ROGERS LABS, INC.

Equipment: FCC ID: QOR X100

FCC Rules: Part 90 (LMR Transceiver)

Re: Requested additional information.

Spurious Emissions at Antenna Terminals

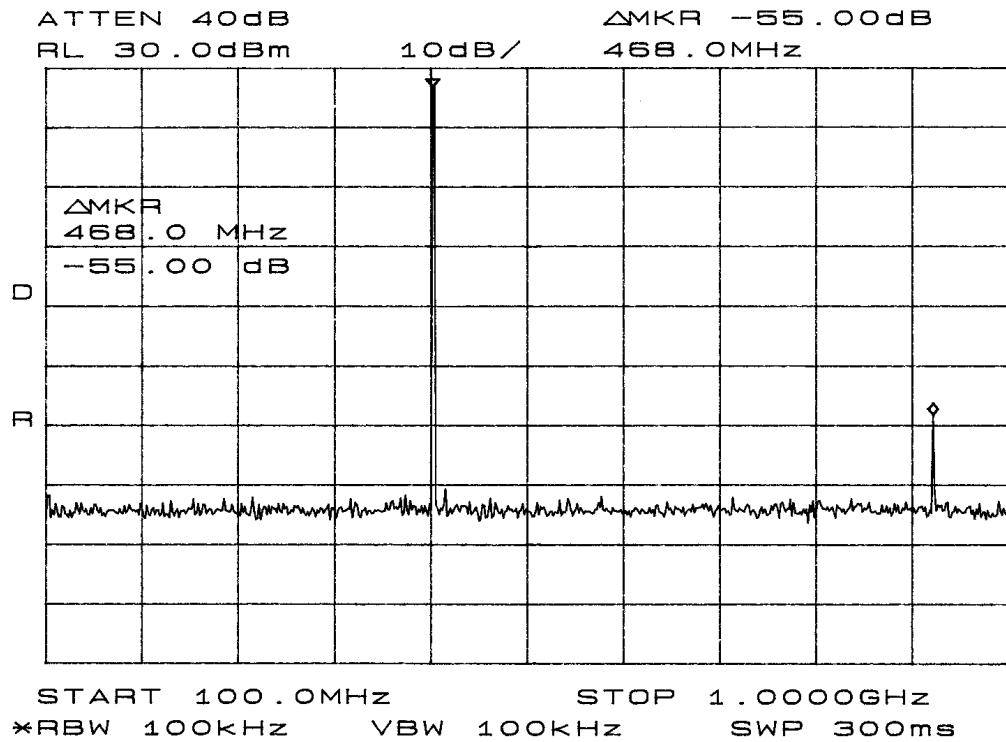
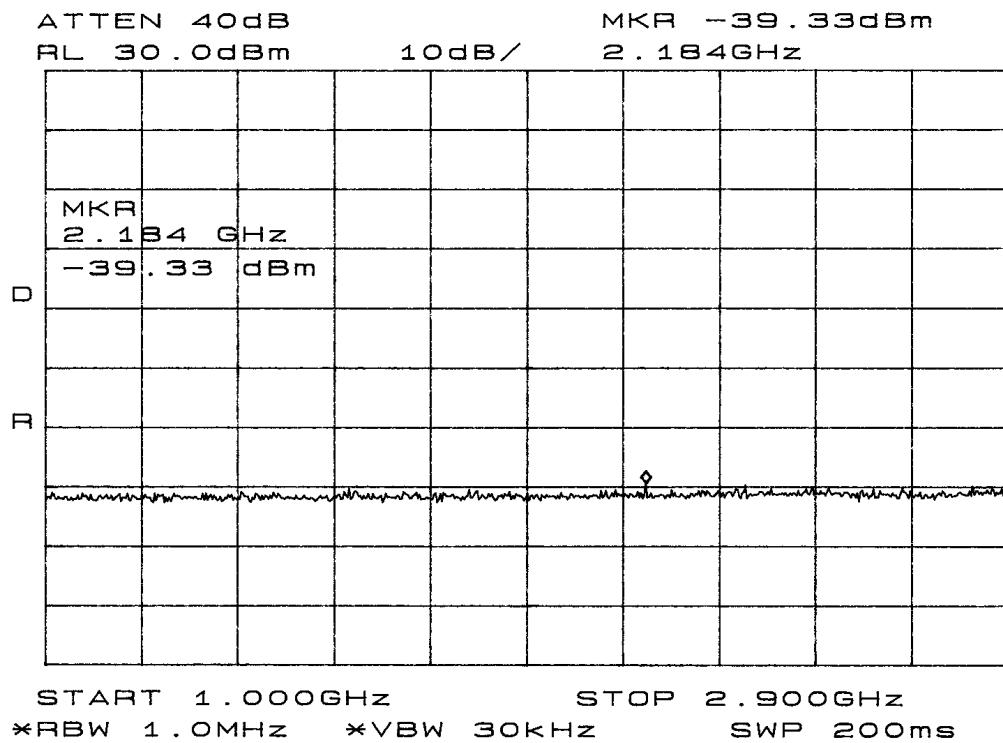
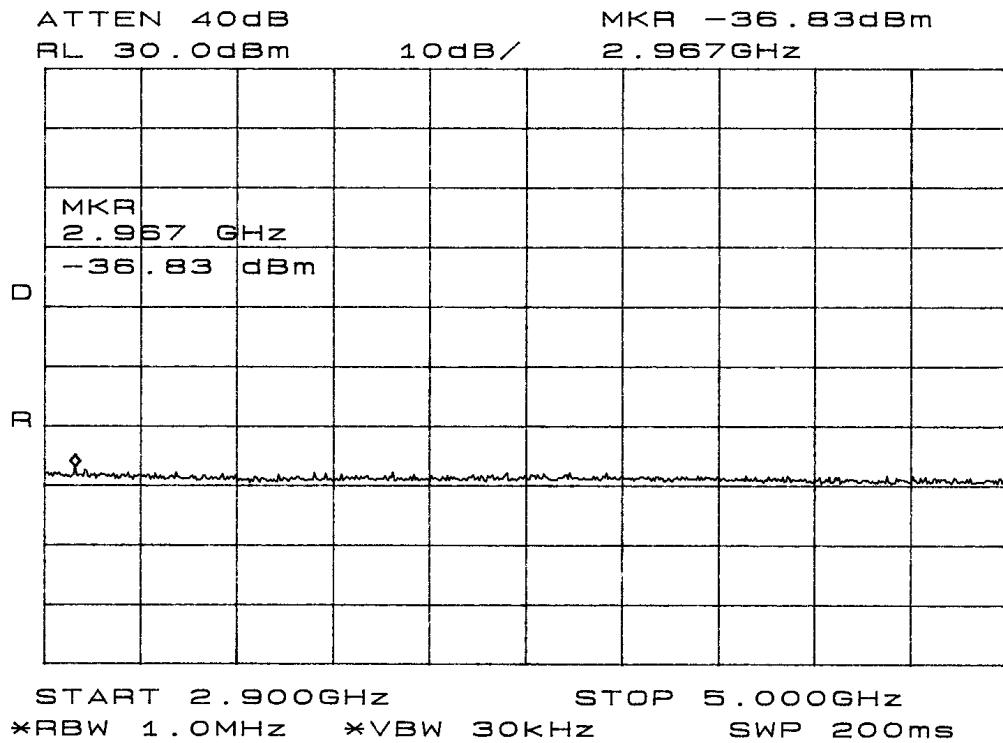
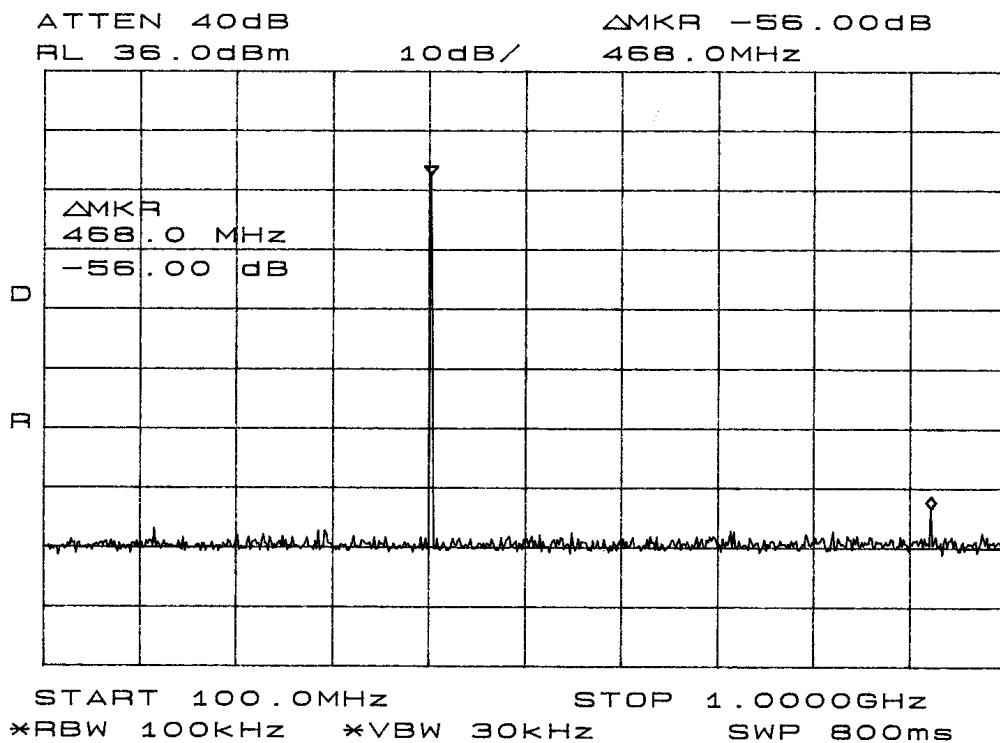
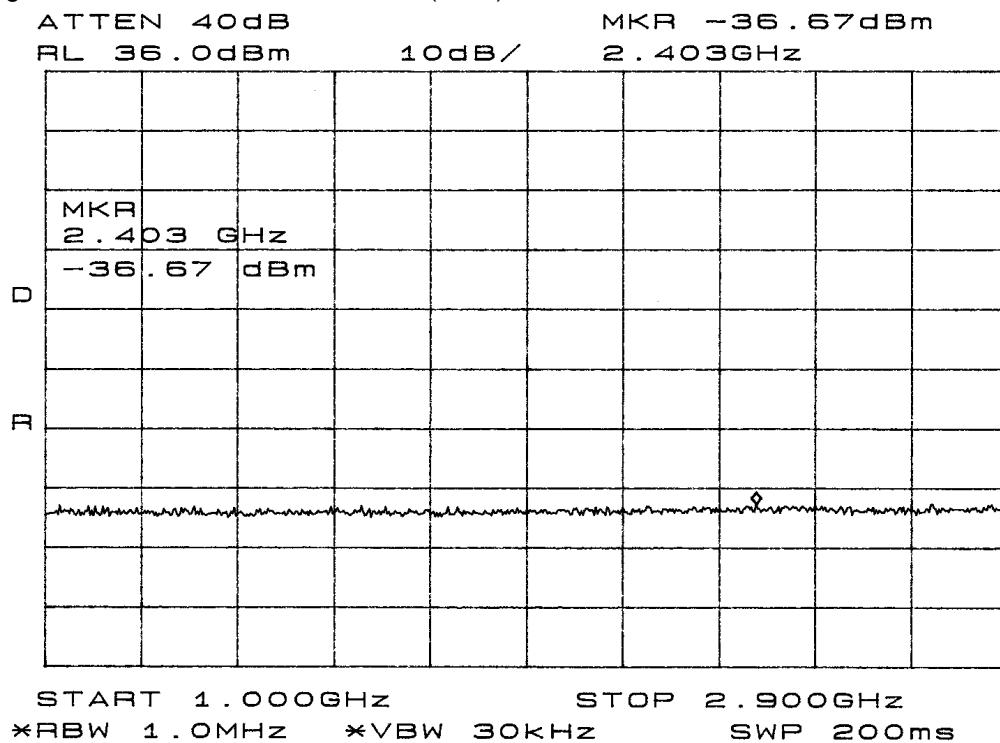
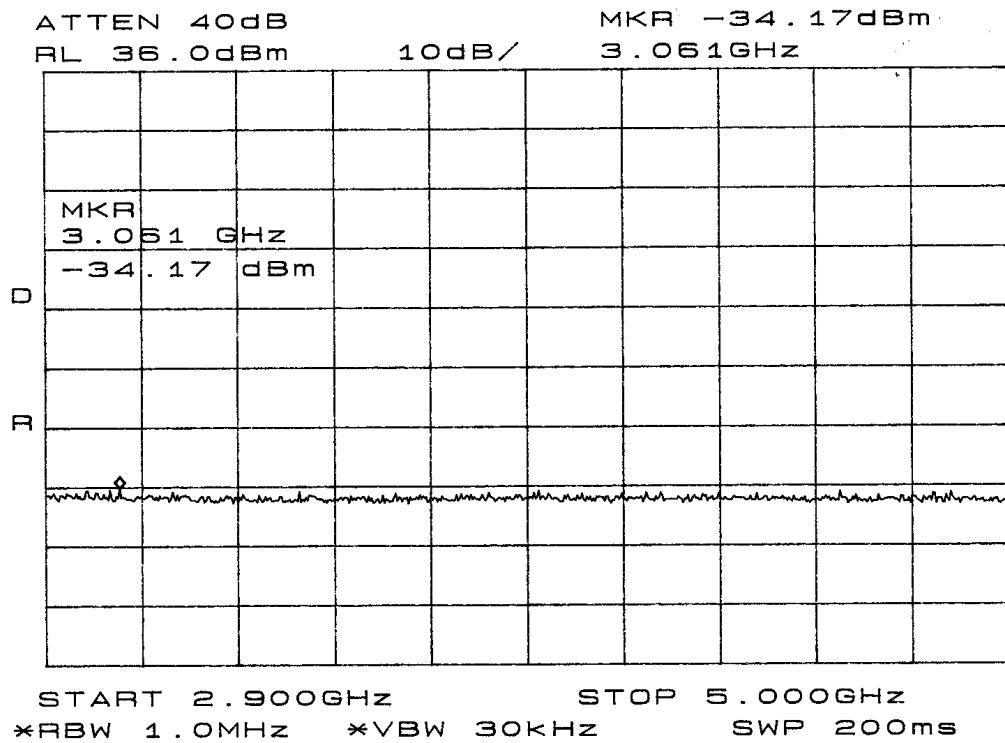
4) Justification for RBW of 100 KHz used for the conducted spurious emissions spectral plots on page 14-16 of 28. Section 90.210 (m) requires at least 1 MHZ RBW above 1 GHz. Redo plots as appropriate.

4.) The spurious responses of the transmitter were measured with an analyzer resolution bandwidth of 100 kHz for frequencies up to 1 GHz. A bandwidth setting of 1 MHz was used for the measurements made above 1 GHz. The plots shown in the report were taken at the antenna terminal in the screen room and the analyzer bandwidth was not adjusted to 1 MHz since the intention was to resolve the spurious emissions for clarity. New plots were produced using the 1MHz bandwidth and shown below. The increased bandwidth does not change the results of the spurious emissions previously reported.

The radio frequency output was coupled to a HP 8562 Spectrum Analyzer. The spectrum analyzer was used to observe the radio frequency spectrum with the transmitter operated in a normal mode. The frequency spectrum from 100 MHz to 5.0 GHz was observed and plots produced of the frequency spectrum. Figures 1 through 6 represent data for the X100 (xx). Data was taken per 2.1051, 2.1057, and applicable paragraphs of Part 90.

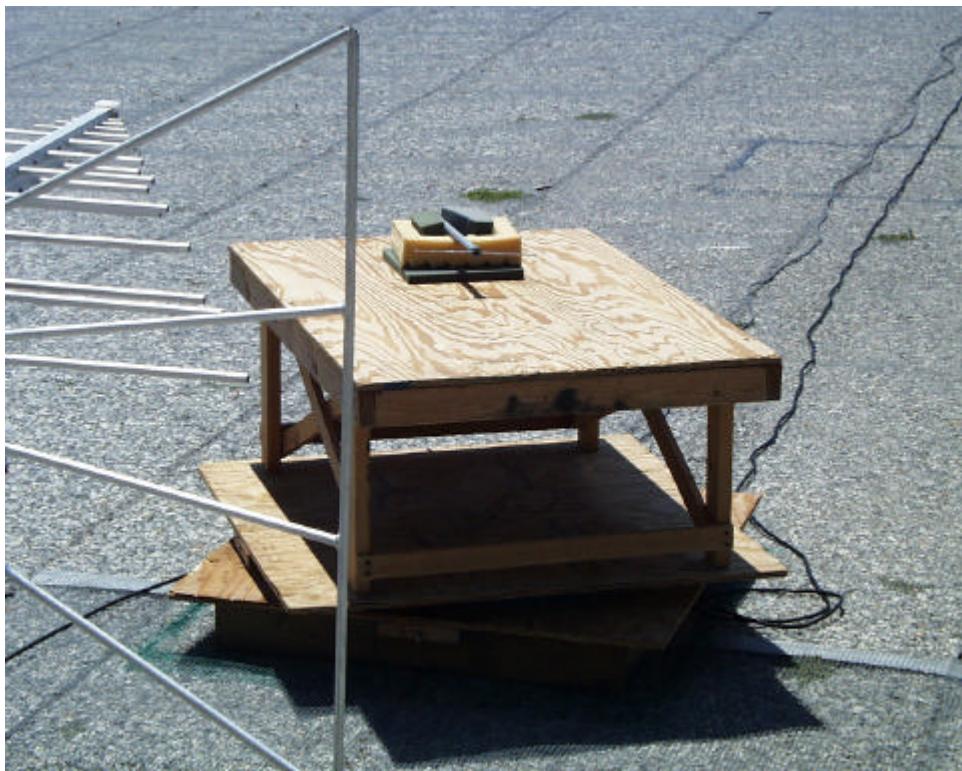
5) Confirm that the substitution method was used for all Radiated Spurious emission testing. Please provide a photograph with the substitution antenna in place. Please provide all supporting data and a sample calculation.

5.) As stated on page 17 of 28 in the report, the substitution method was used to measure the spurious radiation field strength. The supporting data with sample calculations are reported on pages 18 and 19 of the test report. A picture of the substitution test antenna is supplied below as per your request.
